A/E Firm: WRA Architects		PM Firm: CBRE Vanir JV	Date: 12-10-2025
Org #: 159	School Name: L.L. Hotchkiss Elementary School	Bid Pack #/ CSP#: 207325	Addendum #: 1

**DALLAS INDEPENDENT SCHOOL DISTRICT
PROCUREMENT SERVICES
ADDENDUM NO. 1
CSP 207325 – L.L. Hotchkiss Elementary School - Renovation**

The Purpose of this Addendum No. 1 is to provide an alternate bid and updated the drawings and specifications:

6 Enlarged Site Plan - ADA Parking
1" = 20'-0"

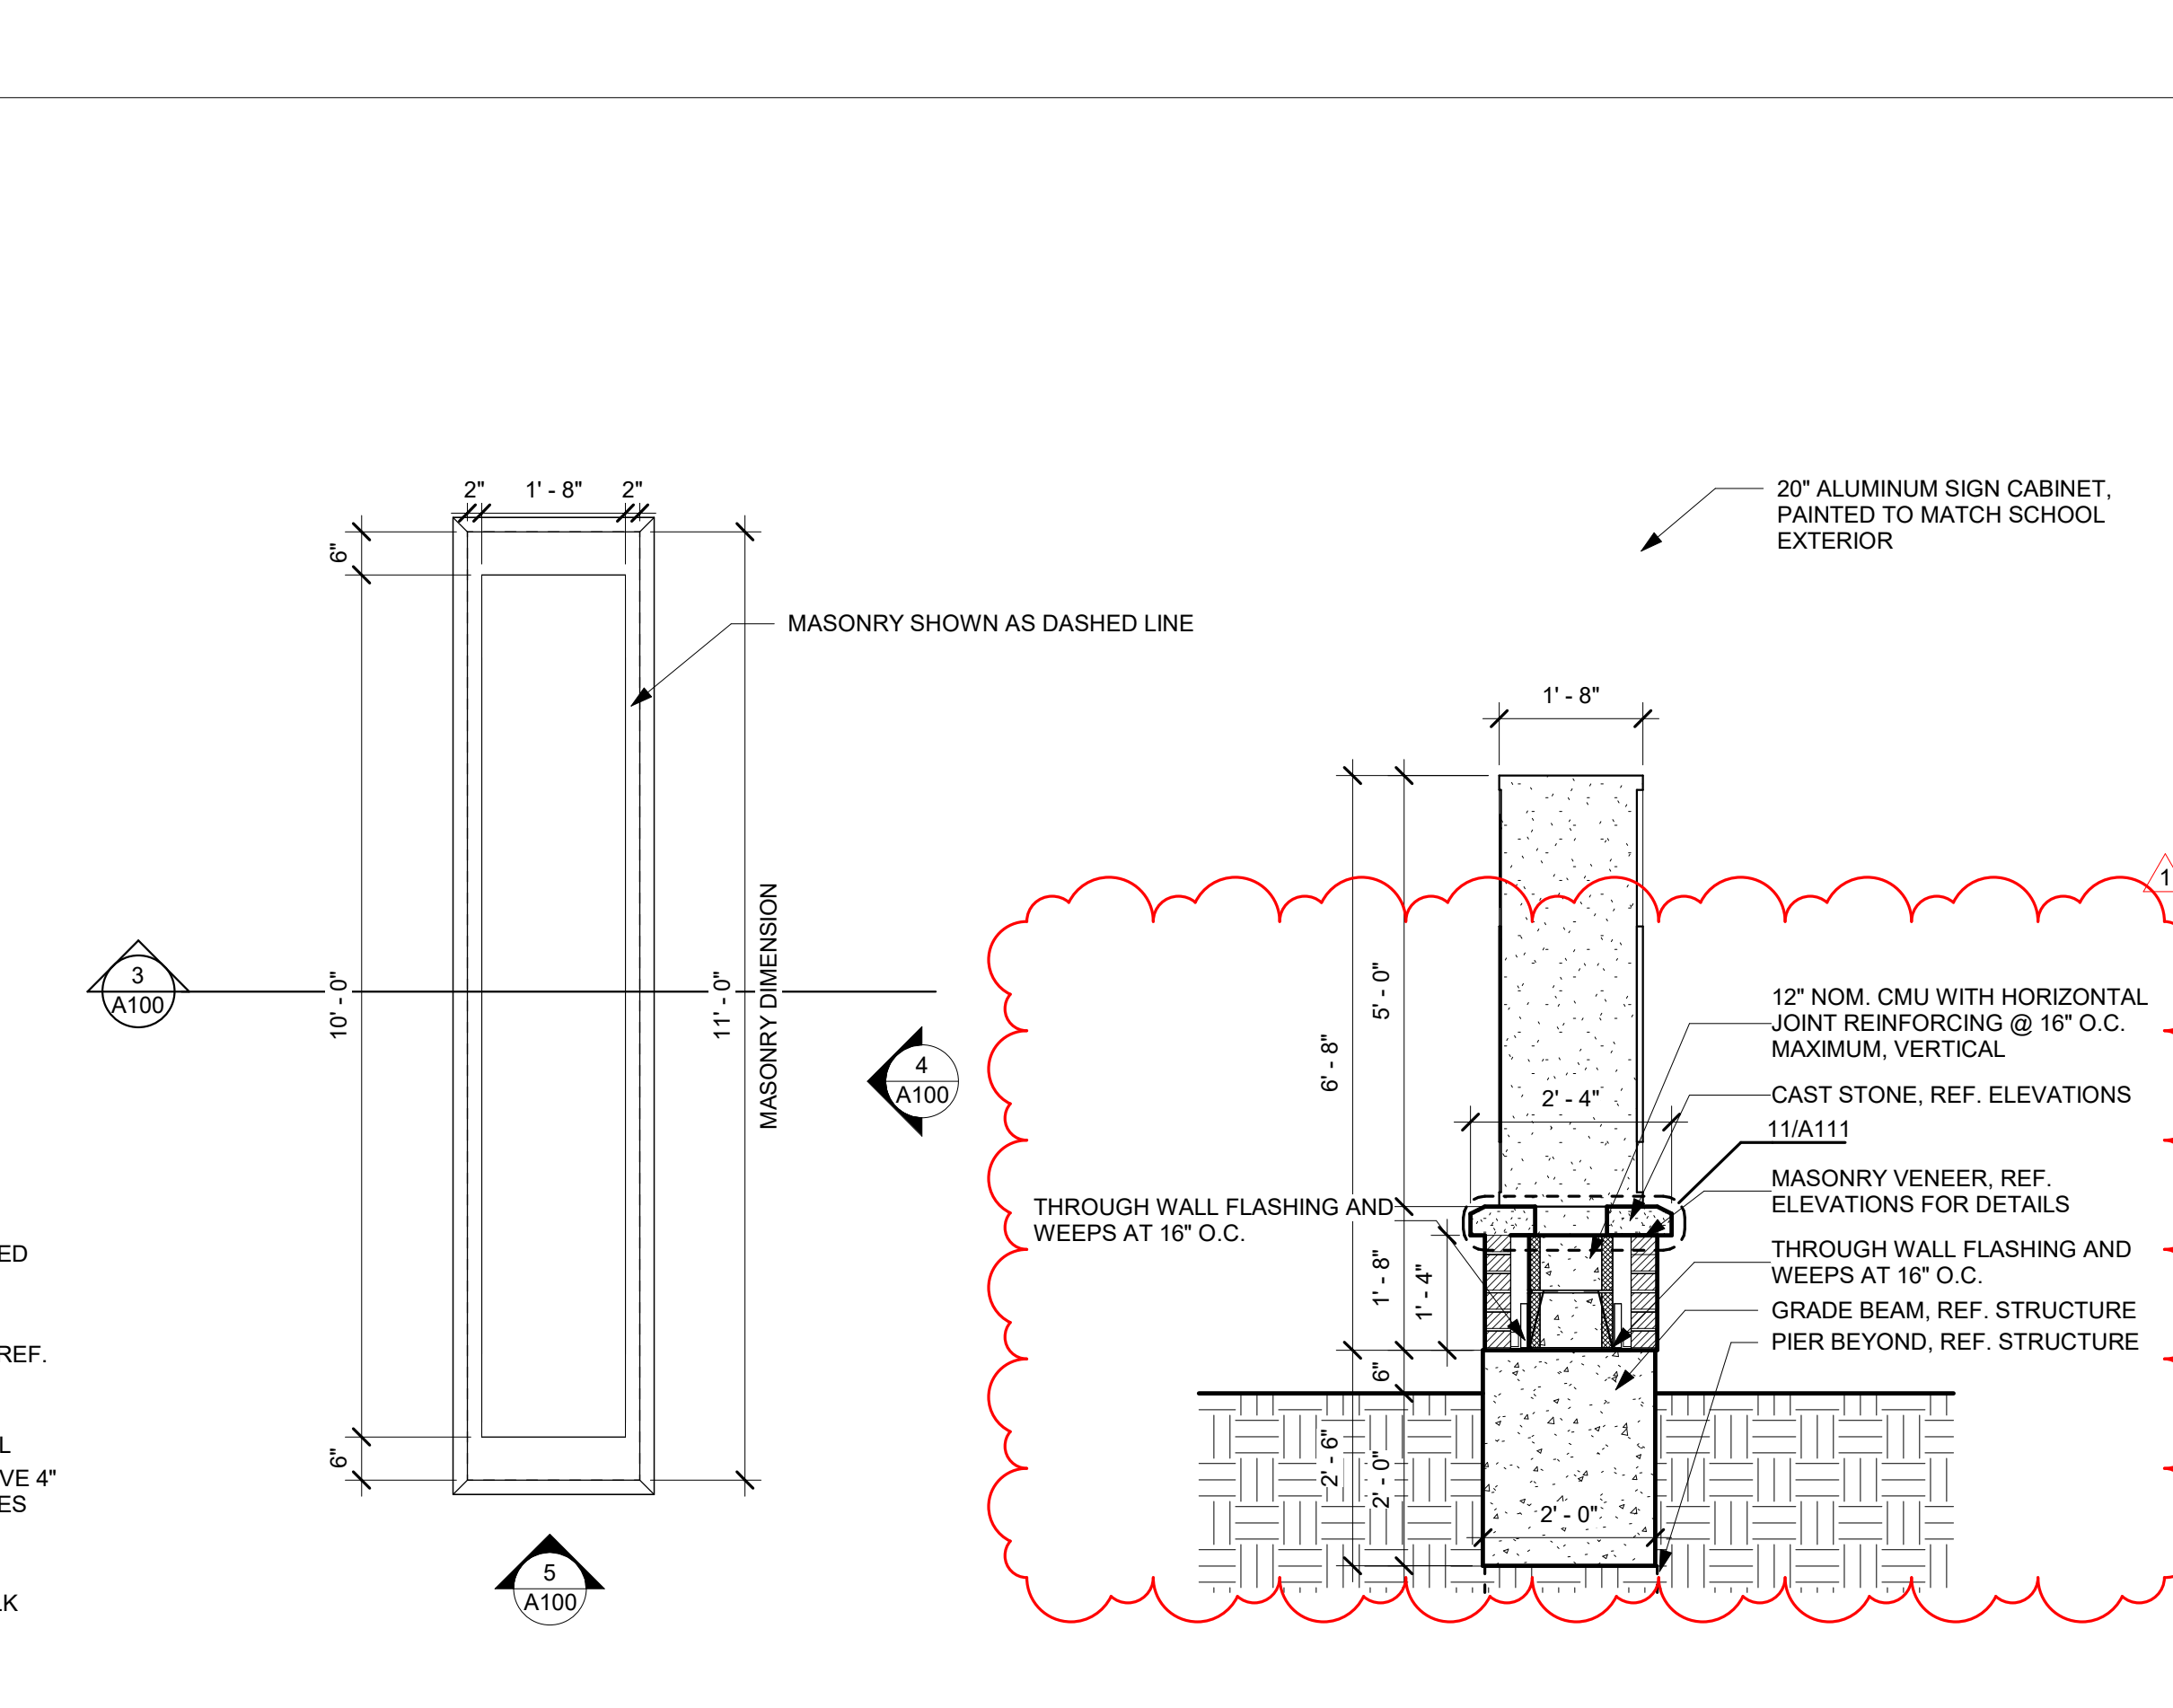
- A. CLARIFIED** no portables on existing site conditions
- B. REVISED** height of marquee masonry Detail 3, 4, 5 of A100
- C. REVISED** dimensions to detail 6/A100
